HISTORIC AND DESIGN REVIEW COMMISSION

October 07, 2015

HDRC CASE NO: 2015-376
ADDRESS: 3006 BROADWAY
LEGAL DESCRIPTION: NCB 3866 BLK 12 LOT 1, 2 & 3
ZONING: C2 RIO-1
CITY COUNCIL DIST.: 2
APPLICANT: Edward Hernandez
OWNER: Mauricio Marcushamer
TYPE OF WORK: Conceptual approval of new construction
REQUEST:

The applicant is requesting conceptual approval to demolish an existing fast food restaurant and construct a new multi use structure to front Broadway. Signage is not a part of this request.

PERSPECTIVE

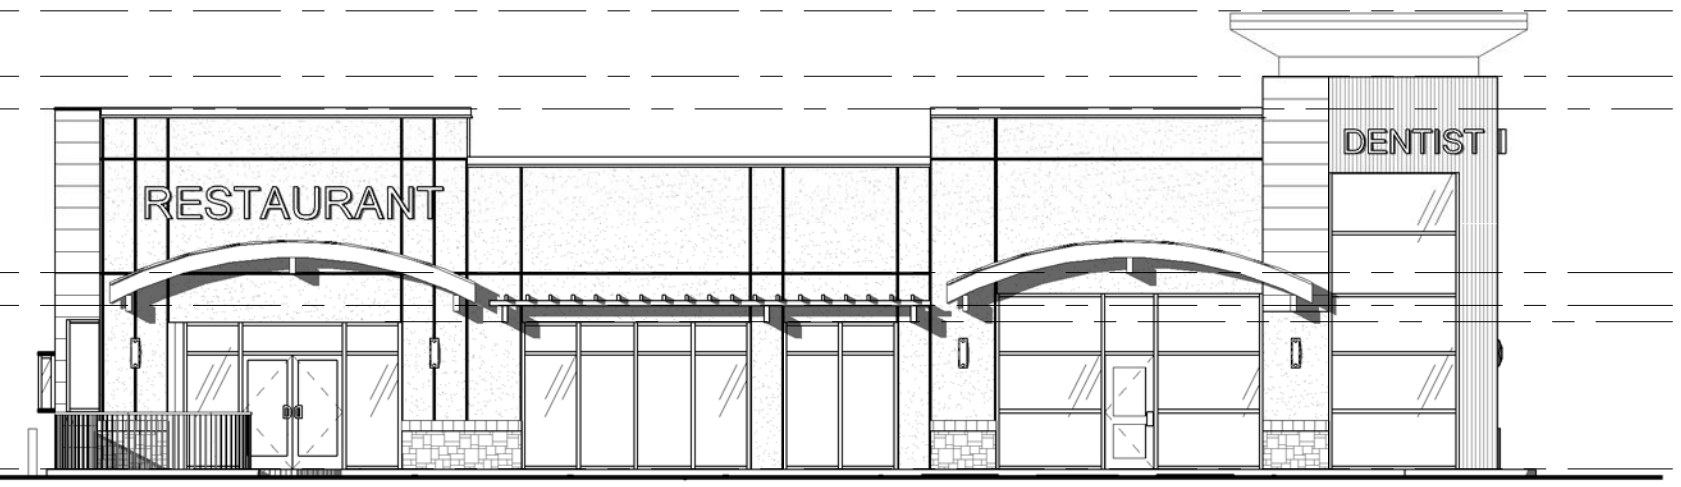
- a. The proposed new construction at 3006 Broadway was reviewed by the Design Review Committee on September 24, 2015. At that time, committee members commented on a previously submitted site plan which featured an automobile drive through with the structure sited toward the rear of the lot. Since that time the applicant has submitted an updated site plan with the structure fronting Broadway without an automobile drive through. Committee members noted that many of the proposed architectural elements were appropriate as well as materials.

- f. Buildings should be sited to help define active spaces for area users, provide pedestrian connections between sites, help animate the street scene and define street edges. The applicant has proposed to site the building at the corner of Broadway and E Mulberry to feature primary entrances fronting Broadway which both defines the street edges and animates the street scene. This is consistent with the UDC Section 35-673(b).

Staff recommends conceptual approval of the proposed site plan, building massing and architectural details. Staff recommends that the applicant provide additional information regarding landscape design, building materials, site and architectural lighting prior to returning to the HDRC. An archaeological investigation is required as a stipulation of this

A1.2

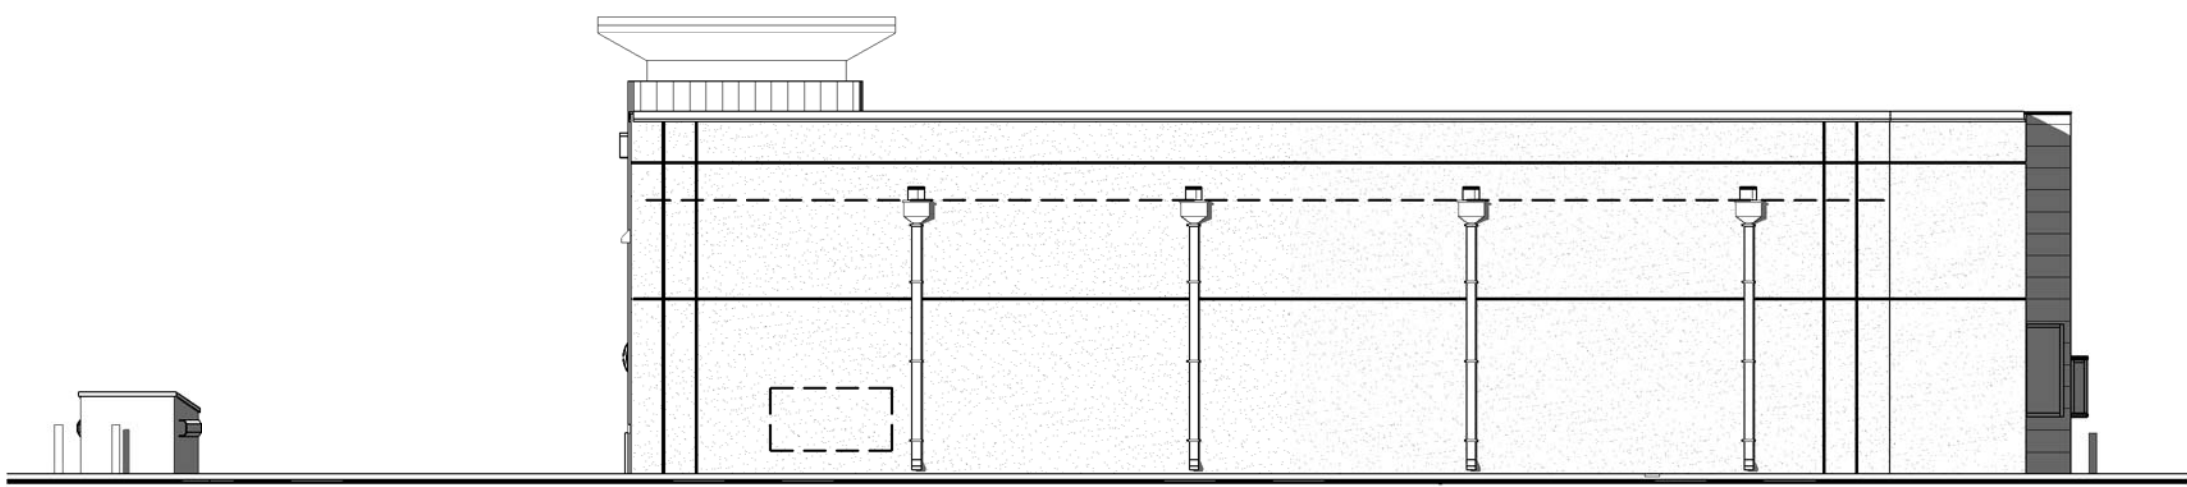
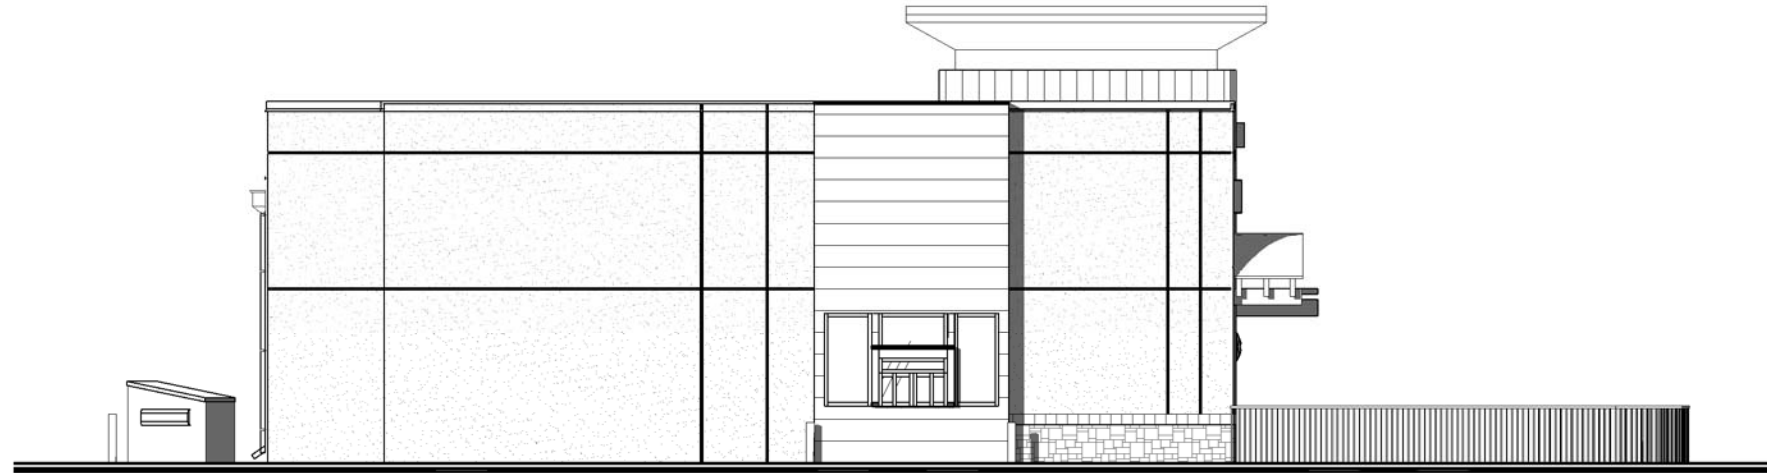
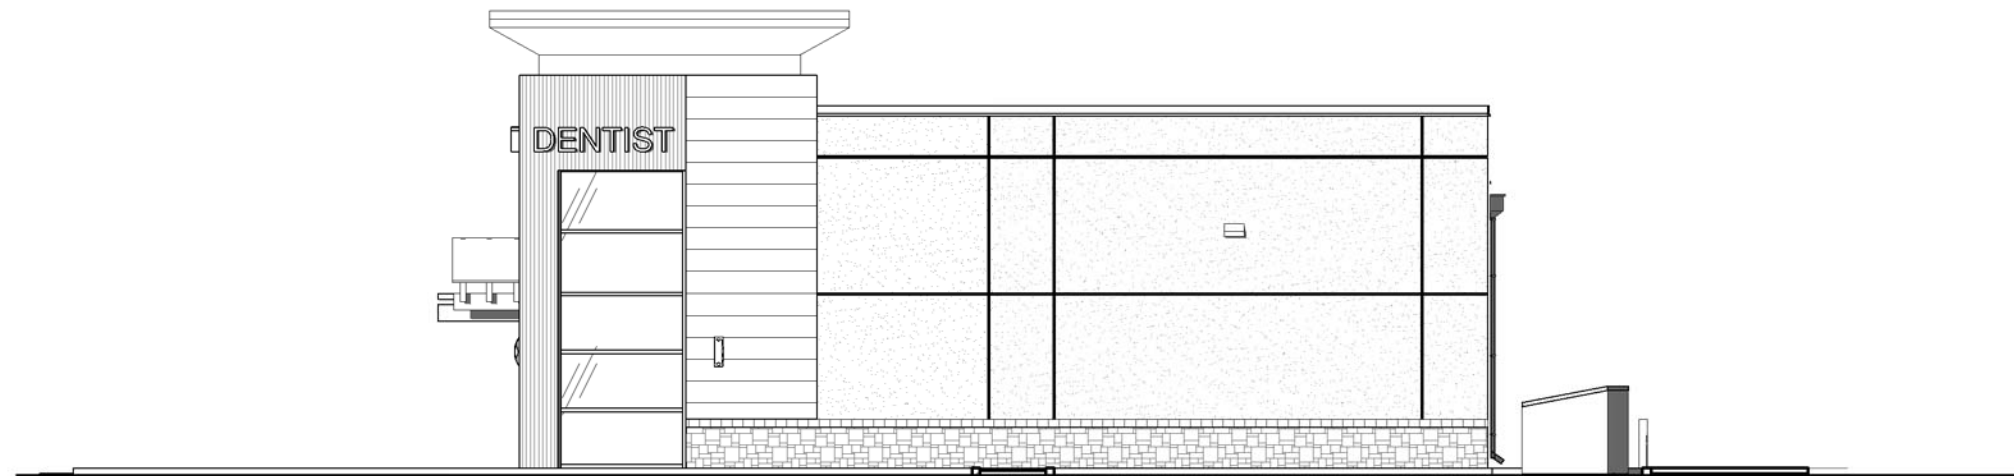
- m. In regards to window fenestration, the UDC Section 25-674 (2) states that windows help provide a human scale to a façade and therefore should be recessed at least two (2) inches within solid walls, they should relate in design and scale to the spaces behind them, they shall be used in hierarchy to articulate important places on the façade and grouped to establish rhythms and that curtain wall systems should be designed with modulating features such as projecting horizontal and/or vertical mullions. The applicant is responsible for complying with this section of the UDC.
